Re: Permit No. M-1980-244; Cripple Creek & Victor Gold Mining Company; Cresson Project; Adequacy Review Response to Technical Revision 133 – Clay Borrow Source

On February 16, 2023 Newmont Corporation's Cripple Creek and Victor Gold Mining Company (CC&V) received the Division of Reclamation, Mining, and Safety (DRMS) first adequacy review of Technical Revision (TR) 133 to Permit M-1980-244, proposing to mine a clay borrow source on the northern perimeter of the WHEX pit.

NewFields		CLIENT CRIPPLE CREEK & VICTOR GOLD MINING COMPANY	
PROJECT		VLF2 PHASE 3	
TITLE WHEX PIT CLAY EXCAVATION - 10140'		FILENAME 0106.056.083F	
		FIGURE NO. 1	REVISION B

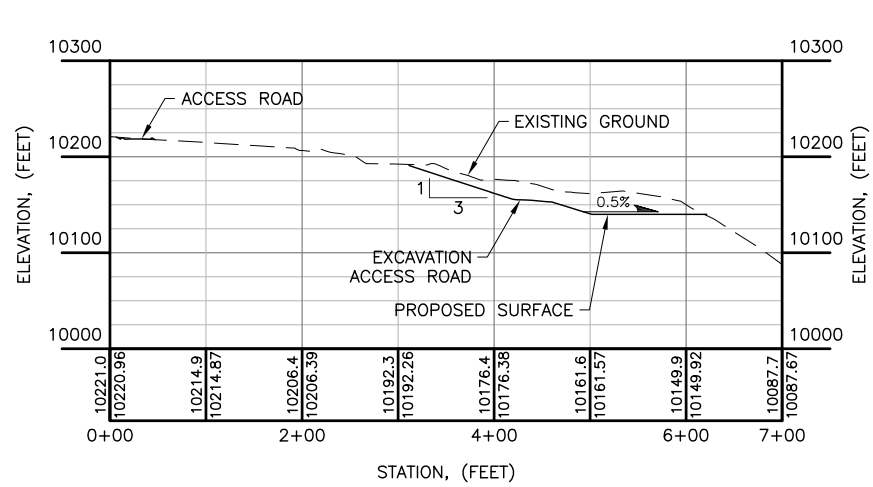
7. **Figures 1 – WHEX Pit Clay Excavation and 2 – WHEX Pit Clay Excavation Reclamation are missing a date or signature. As required by Rule 6.2.1(2)(b) and (c), please provide revised figures with dates and signatures.**

Please see the revised figure.
